# Review and Analysis of the CityView RFI Response submitted April 2021

**PUGET NEIGHBORHOOD WORKING GROUP**

**Application Type:** Planned development (PDP2019-0015)/Design review (DR2019-0036)/Critical area permit (CAP2019-0037)/SEPA checklist (SEP2019-0039)

Figure 1: Rendering Year 2020

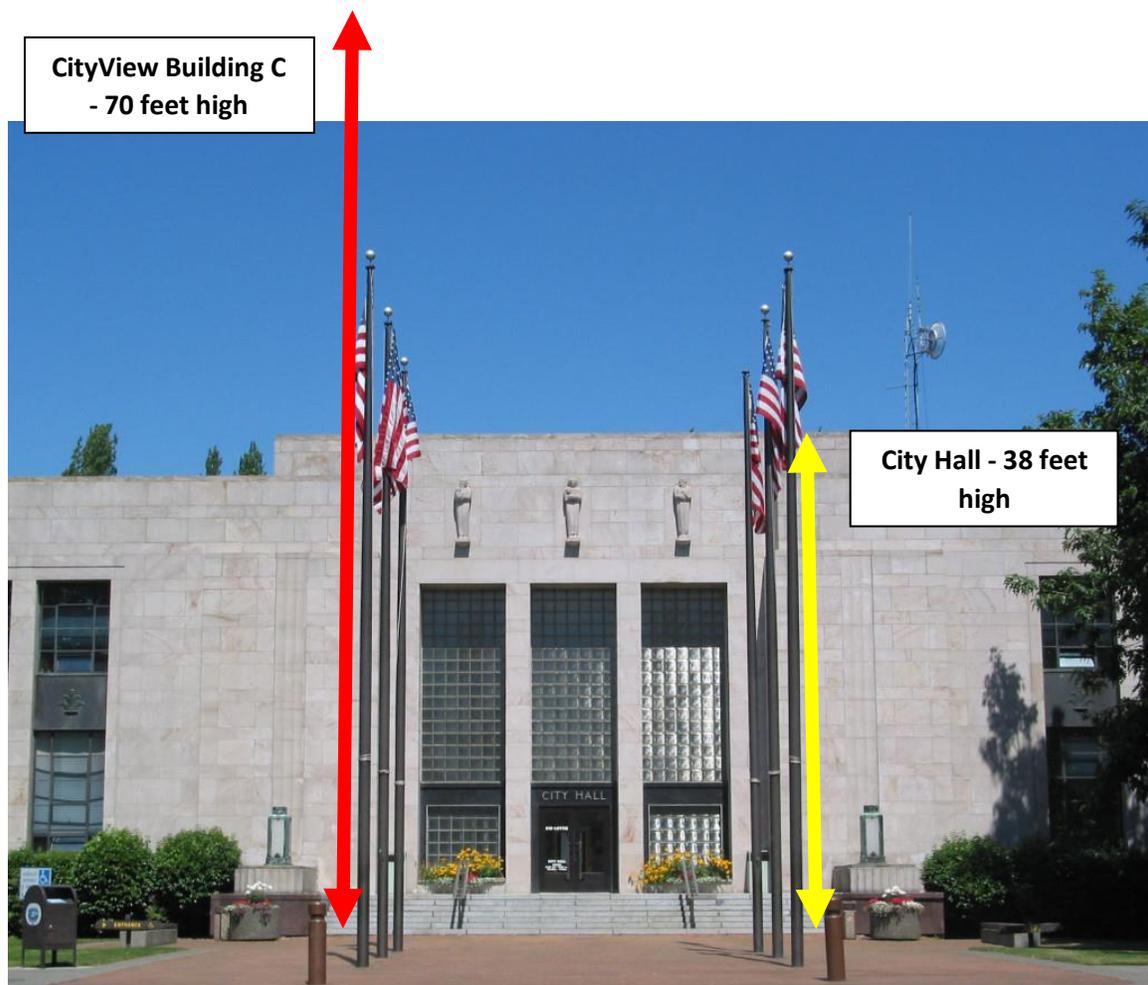
*The same design, size and number of buildings proposed in 2020 has been submitted again in 2021, as shown below.*

***The same design, size and number of buildings proposed in 2020 has been submitted again in 2021.*** The RFI Response states the visual appearance has been amended by applying different color and material schemes to the façade.

- There is no change to the size and impact of the buildings.
- The set-backs of 160 to 250 feet equate to looking at your neighbor's home located across a cul-de-sac. Due to the size and placement of the three buildings on the hill, they will be an overwhelming sight to the Nevada Street and Marionberry Ct neighbors.

Illustration from RFI Response – Updated Landscape Buffer Plan

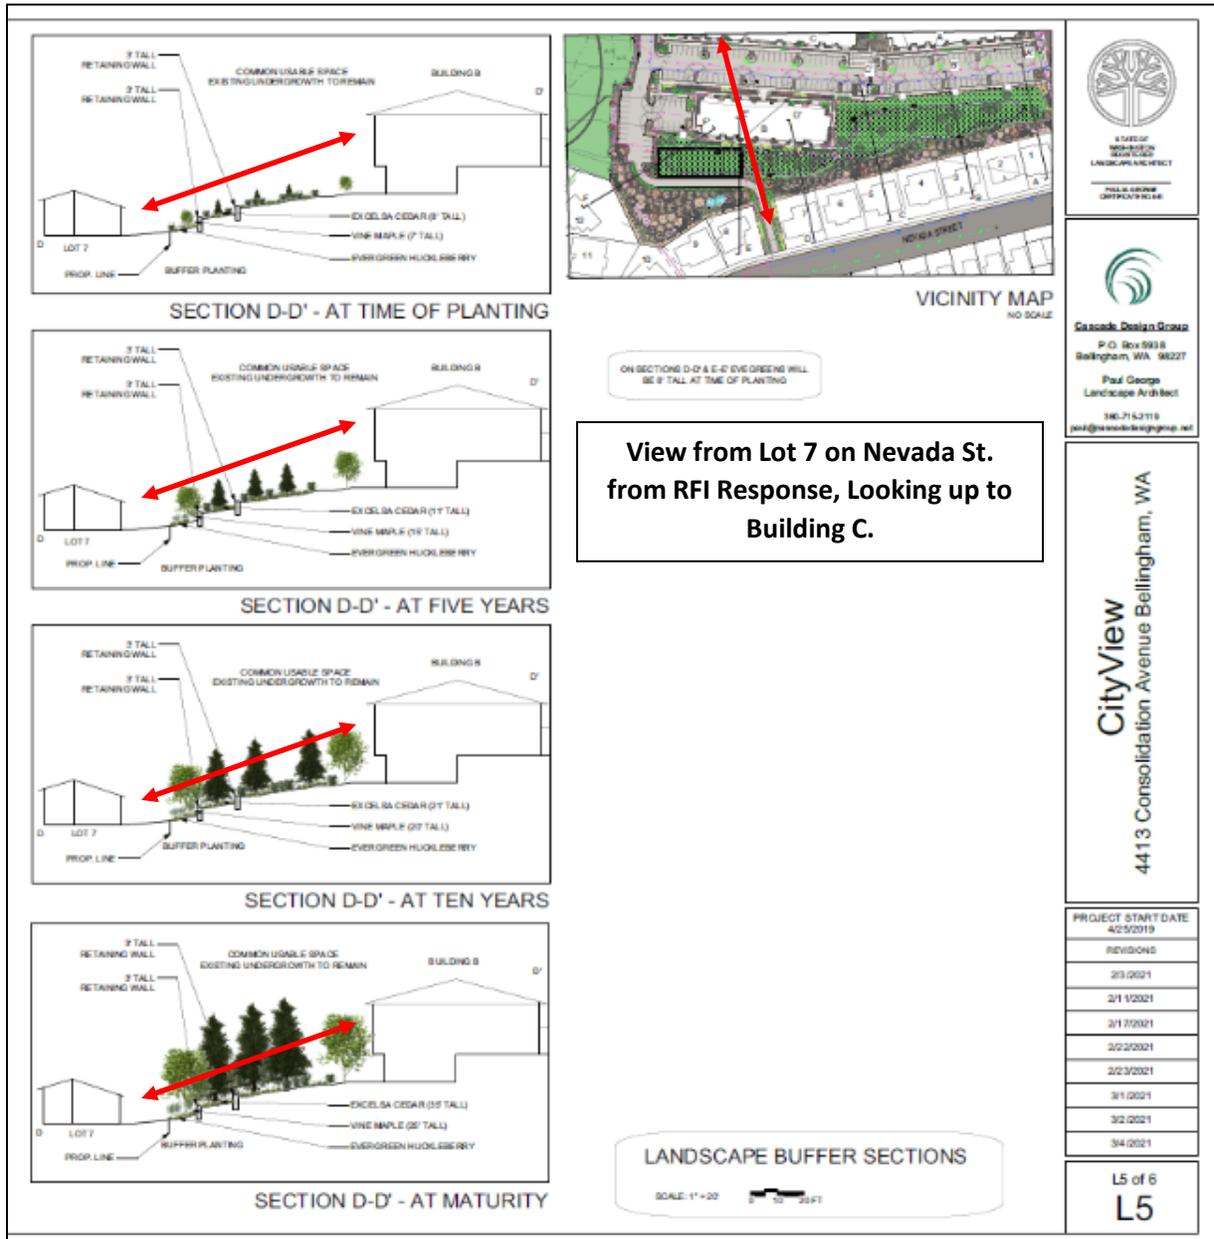
Additional cross sections have been provided. On the next page is a copy of the cross section for Lot 7 (located south of the "emergency drive"). This cross section shows that from this location, ***Building C will be very visible for at least ten years***, and not "screened" until the new plantings reach maturity (20+ years?).

- Homes along Nevada Street and Marionberry Ct., will have big, highly visible, buildings to view for years.
- Light from exterior illumination will be visible all night from building and parking lot lighting.
- When interior apartment lights are on, Building C in particular will be "a beacon on the hill," visible from all neighborhoods bordered by Interstate 5.

A landscape plan showing how single-family homes will be visually screened was submitted. However, this *illustration shows vegetation and trees at Maturity, which is perhaps 20+ years out.*

- Current residents will have to wait years before an effective visual screen grows to maturity.
- The height of the proposed plantings (8 feet or less), is not an effective visual barrier.
- With parking planned for 254 vehicles (and more with visitors), the lack of an effective visual barrier will result in major light pollution from cars entering, parking and leaving the development.

Drainage: Area of Concern (Figure 4: Cascade Engineering Group)

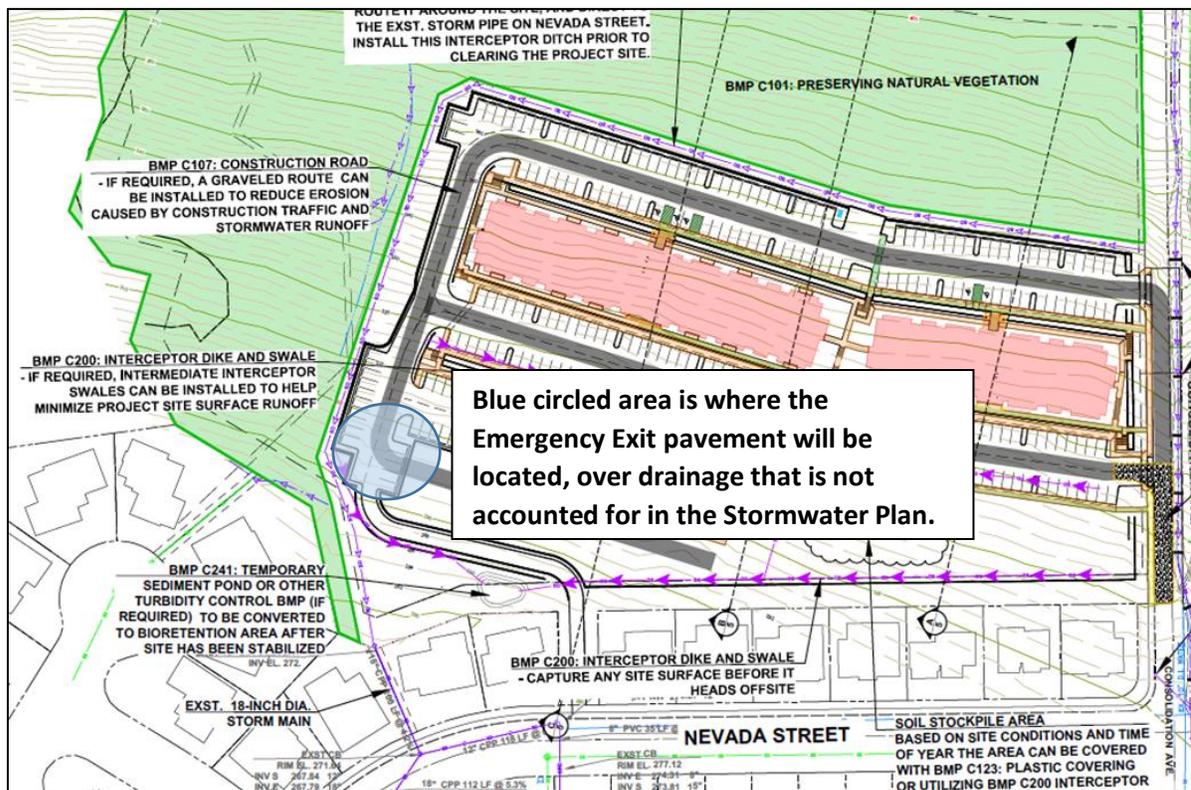
The revised Critical Area report failed to identify an open drainage ditch located directly below Wetlands B. This was previously identified by a neighbor in a Project Comment submitted a year ago (May 2020).

Figure 4 from the Preliminary Stormwater Report prepared this year by Cascade Engineering Group states that, “Surface runoff from the project site flows west and currently is captured in the Nevada Street conveyance system.”

- The Critical Area Report: Wetland Mitigation Plan, states, “Water appears to disperse into the subsurface below Wetland B – as no downgradient channel was observed.”
- There is an existing surface drain (see Preliminary Grading Plan map, next page) that runs from the northern property line that is not mapped. Given the location, this drain is collecting water from an area that directly below Wetland B.
- From the narrative and Figure 4, it appears the subject water is drained into a storm drain through Marionberry Ct. There is no connection between the surface drainage ditch and the storm drain.
- Water is diverted into an open air drainage ditch that extends through and behind yards on Marionberry Ct. This drainage is not accounted for as seen in the pictures below and on the next page taken during a February, 2021 rainfall event.

**Screenshot 2: Water flowing behind homes on south/southeast area of Marionberry Ct.**

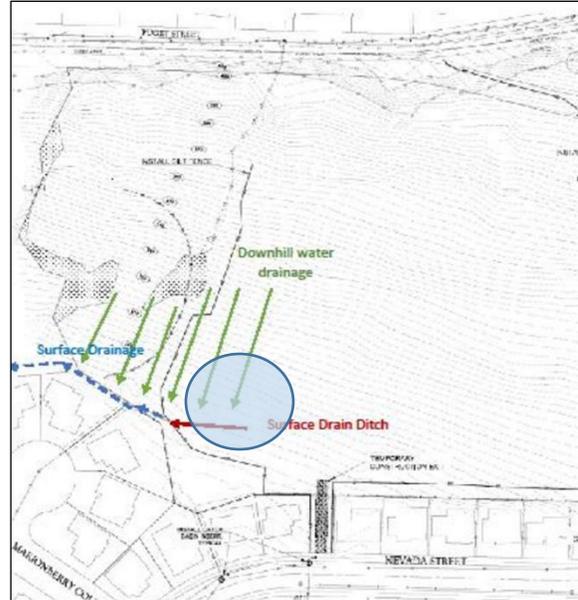
**Screenshot 1: Water emerging from area near Wetlands, both from subsurface (top circle), and flowing right to left from surface drainage.**

**Screenshot 3: Water from area near Wetlands, flowing right to left as surface drainage, towards Marionberry Ct.**

Preliminary Grading Plan with Surface Drainage Ditch Identified**RESTRICTED EMERGENCY ACCESS ROAD NOT REQUIRED**

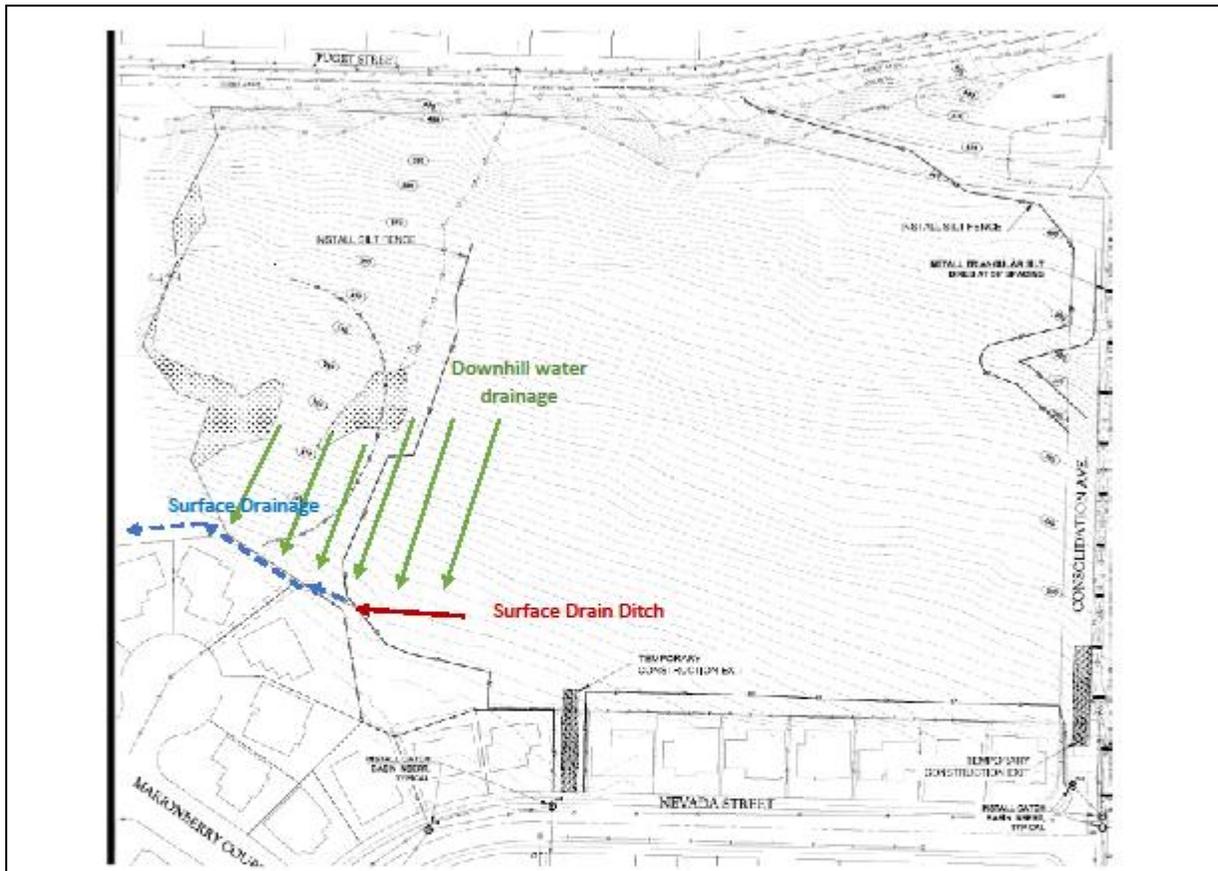
The Preliminary Grading Plan and Critical Area Report: Wetland Mitigation Plan, both fail to include an important drainage ditch located directly below Wetlands B. Additionally, an unnecessary assumption concerning fire access is used to justify encroachment/construction on the wetlands buffer.

However, there is an existing surface drain (see Preliminary Grading Plan map, next page) that runs from the northern property line, extending south approximately 100 feet. Given the location, this drain is collecting water from an area that directly below Wetland B.

Much of the water is actually diverted into an open air drainage ditch that extends through and behind yards on Marionberry Ct. This creates an intermittent stream depending on the amount of run-off collected up the hill. Below is the Preliminary Grading Plan – temporary barriers, with the surface drainage outlined. This drainage is apparently not accounted for, which should be part of the Wetlands B evaluation.
